Technical Note

2012:28

Initial review of chemical and erosional processes within the buffer and backfill – Geochemical processes

Author: David Savage
            Savage Earth Associates Limited, Bournemouth, U. K.

Figure 1 Hydraulic conductivity of MX-80 (WyR1) bentonite measured at different densities and molar concentration of NaCl in the saturating solution (from Karnland et al., 2006).

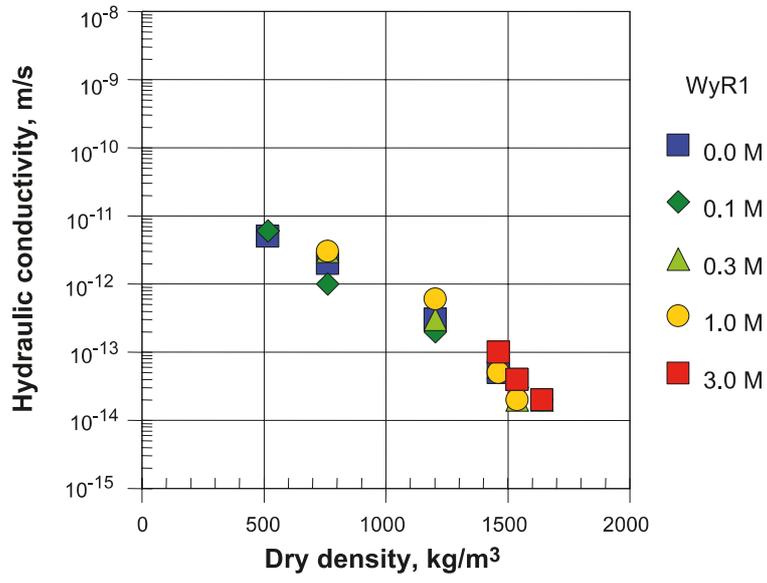
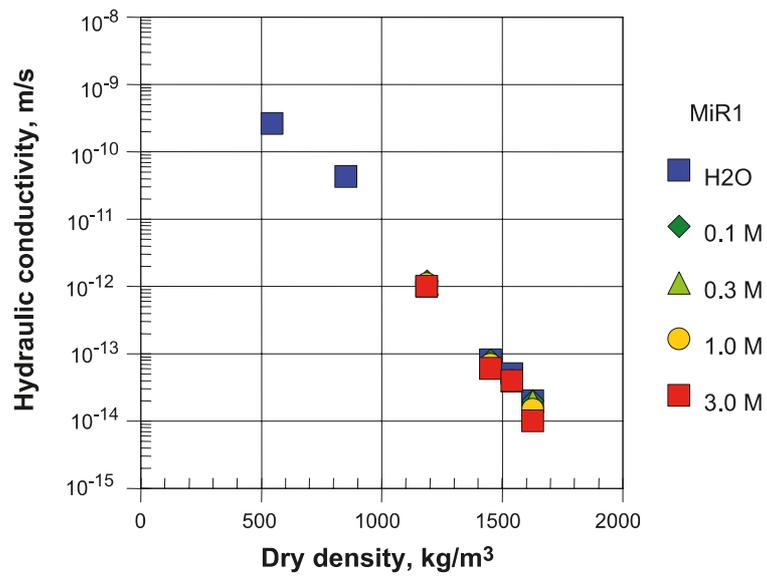
These Figures show that data for Na- and Ca-bentonites are similar at target compaction densities, but it can also be seen that the gradient of hydraulic conductivity with density is much greater for Ca-bentonite than the Na form, so that at 1000 kg m^{-3} dry density, the hydraulic conductivity of Ca-bentonite is about an order of magnitude greater than that for Na-bentonite. Consequently, the hydraulic conductivity of Ca-bentonite will be more susceptible to changes in density, say through erosion, than the Na-form. Pusch attributes this difference in permeability behaviour to the microstructure of the clay, with the Ca-form tending to aggregate in larger 'stacks' of clay lamellae than the Na-form (Pusch, 2002).

There are a number of datasets describing the hydraulic behaviour of Na-bentonites, but relatively few for Ca-bentonites and Ibeco RWC in particular. Indeed, in the SR-Site 'Buffer, Backfill and Closure Process Report', SKB comments that "*few tests have been performed on Ibeco RWC bentonite, but the results available indicate that the properties of this material are very similar to the properties of MX-80 at the densities considered for the buffer material*" (SKB, 2010a, p66).

Moreover, from the data available, there are fundamental differences in the pore structure of Ca- and Na-bentonites. This latter behaviour in itself need not necessarily preclude the exchangeability of bentonite types, but it is clear that there are distinctly different material properties resulting from the differences in the exchangeable cation type.

Although additional hydraulic tests on Ibeco RWC are therefore recommended, the differences in material properties between the two bentonites would still remain.

Figure 3 Plot of p_{swell} versus saturated density for a number of bentonites and swelling clays (from Karnland, 2010). The red bar indicates a range of buffer densities relevant for MX-80 and Ibeco RWC bentonites.

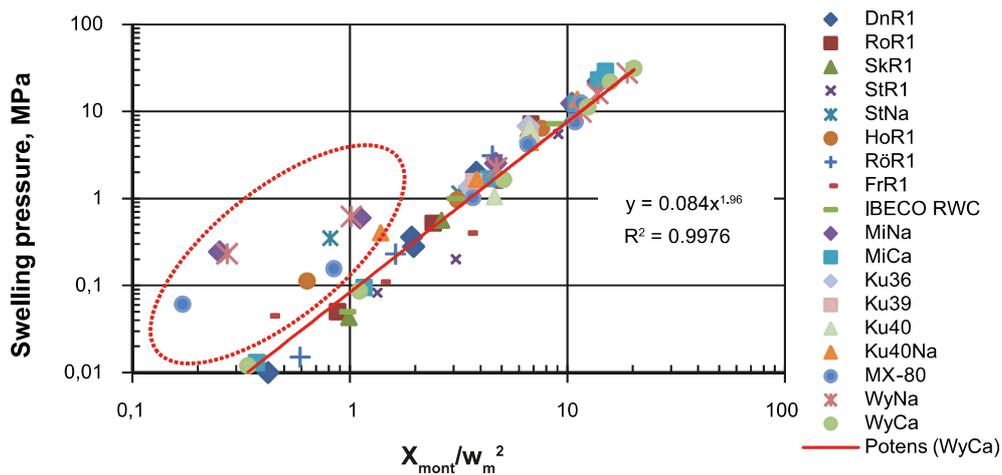
Karnland (Karnland, 2010) has taken the alignment around the red line in **Figure 3** to indicate that the measured relation between the variable $X_{mont}/(w_{sat})^2$ and swelling pressure is of the type $f(x) = B \cdot x^a$. The slope shows that the constant (a) has a value close to 2. Karnland thus considers that an expression for swelling pressure dominated by divalent exchangeable ions may consequently be formulated using:

However, it should be noted that swelling behaviour has tended to be investigated in simple chemical systems only, i.e. Ca-bentonite in $CaCl_2$ solutions or Na-bentonite in NaCl solutions. To be more realistic, further development of these empirical relationships for application in more complex fluids (realistic groundwater compositions) is necessary.

Mechanistic models to describe clay swelling are not currently available. As can be seen from the above, models that attempt to account for the thermodynamic and microstructural properties of compacted clays have been developed, but they rely on empirical evidence to establish a relation between swelling pressure and clay density for a limiting case in which the saturating solution is pure water (Arthur, 2011).

Figure 7 Schematic diagram of the nature of water in compacted bentonite according to a multiple porosity model (from Bradbury and Baeyens, 2003).

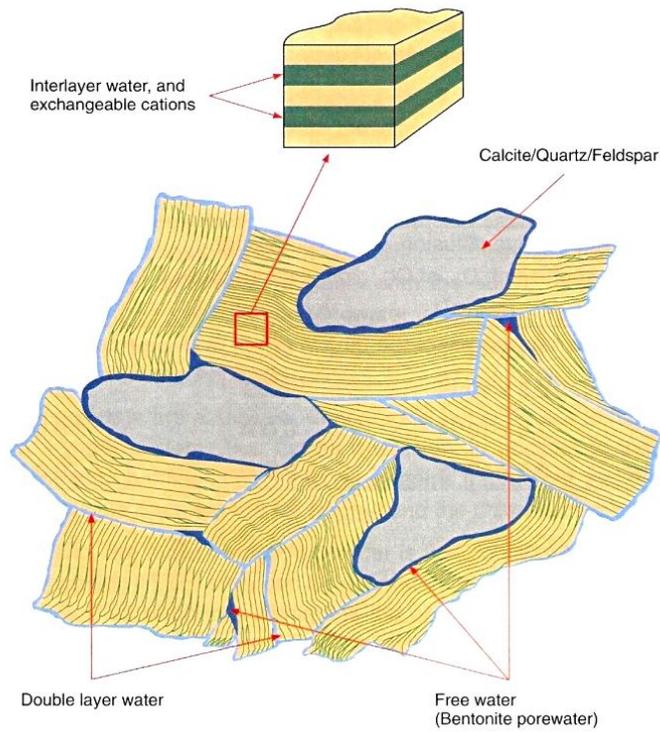
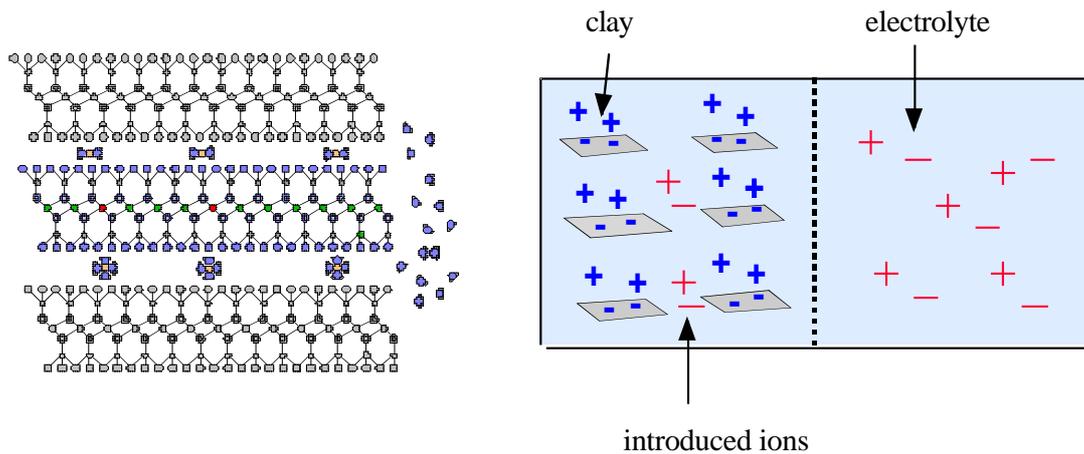
Currently, there is much debate surrounding this issue, but in general, researchers envisage either a system with different porosity types (e.g. Figure 7), or a system with a single porosity (e.g. Figure 8). This issue has been dealt with in detail for SSM elsewhere (Savage, 2011). For the multiple porosity model, the amounts of each porosity type vary with compaction density (e.g. Muurinen and Carlsson, 2007), with 'free water' or 'chloride porosity' being significantly less than the total porosity as compaction density increases.

The single porosity model has large implications for the conceptual view of pore water chemistry and hence, the trigger for buffer erosion. Since in this model, the major part of cations and anions reside in the interlayer pores, this volume is of crucial importance and cannot be ignored in characterising the bentonite pore water chemistry. This approach is thus in sharp contrast to the 'multiple porosity' model where pore fluid is considered to reside in the 'free water' porosity only.

If calculating the evolution of porewater chemistry, it is then an important point which 'porosity' should be considered to evaluate solute concentrations. Seemingly, some authors opt to use the 'free' or 'geochemical' porosity (e.g. Fernandez and Villar, 2010), whilst others use 'total' porosity (e.g. Arcos et al., 2006). Clearly, this can lead to confusion and different results from the same basic assumptions.

Conceivably, it could be envisaged that a transition exists between a multiple porosity type at low to medium compaction densities and a single porosity type at high compaction densities (e.g. Bond et al., 2010). This would then bring greater consistency to the models of pore water evolution, clay swelling and buffer erosion.
